# **Evaluation of the report of Tokyo Electric Power Company regarding the inflow of water that accumulated in the process main building into the incineration building at the Fukushima Daiichi Nuclear Power Station**

15 April 2015  
Nuclear Regulation Authority, Japan

**Figure 2 Accumulated water level in the incineration building (extracted from the TEPCO report)**

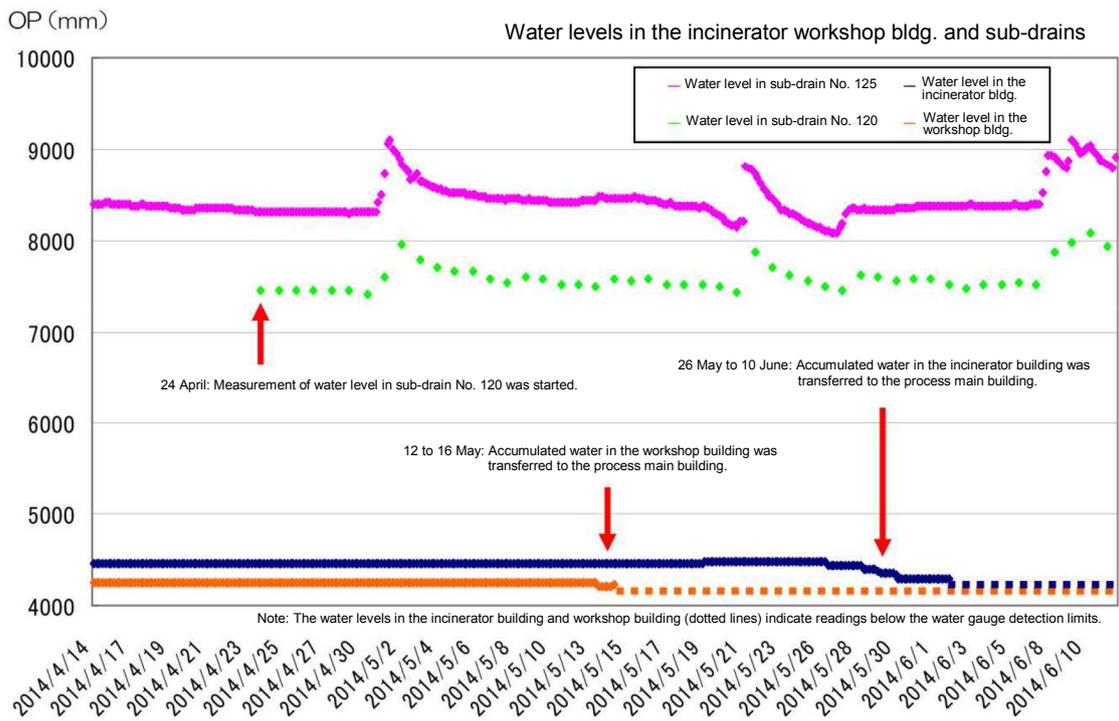
- (i) The accumulated water levels did not change during the period between the confirmation of the accumulated water in the incineration building and the start of the transfer of the water (refer to Figure 2).
- (ii) No significant change was observed in the analysis results of the sub-drain water around the incineration building during the period between the confirmation of the accumulated water in the incineration building and the completion of the transfer of the water (refer to Figure 3).
- (iii) The sub-drain water levels around the incineration building were higher than the level of the accumulated water transferred to the incineration building (refer to Figure 4).

Both the nuclide analysis results and the fact that the accumulated water in the incineration building did not exceed the sub-drain water level indicate that the accumulated water did not leak outside the building. Based on this determination, the NRA concludes that there has been neither environmental contamination that raises any concerns about effects on health or the environment nor exposure leading to concern.

**Figure 5 Distribution panels accommodating circuit breakers for transfer pumps (extracted from the TEPCO report)**

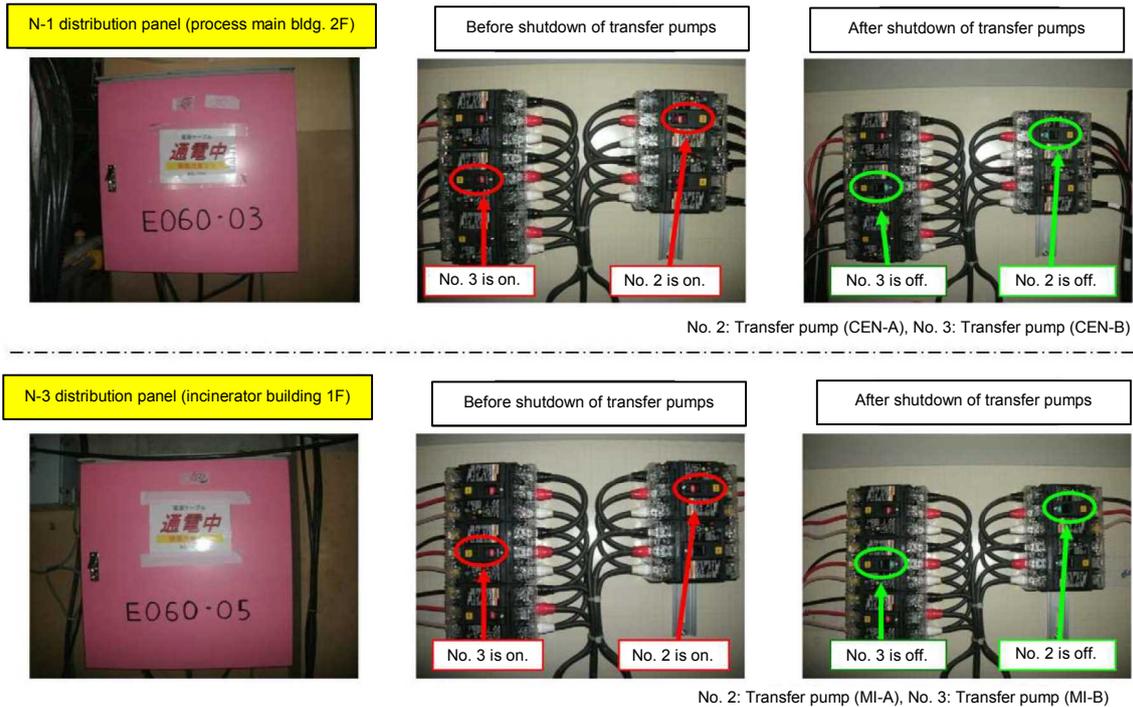
It is highly likely that the circuit breakers for the transfer pumps mounted on the N-1 distribution panel in the process main building and the N-2 distribution panel in the incineration building were closed by mistake during restoration after the work related to shutdown of the power distribution panel (C system) in the process main building, which was conducted on 20 March 2014 (refer to Figure 5). This mistake has four potential causes.

The mistake in operation occurred when the worker operating the power distribution panels in the process main building unintentionally closed the circuit breakers for the transfer pumps. The NRA confirmed that, to prevent such a mistake in operation, TEPCO implemented countermeasures such as affixing labels indicating load equipment names for identification, managing operating results, and strengthening monitoring. The NRA has determined that these countermeasures address the main cause of the mistake in operation in question and will effectively prevent recurrence if implemented appropriately. Further checks shall be made to ensure continued progress in implementing the countermeasures by safety inspections and other means in the future.
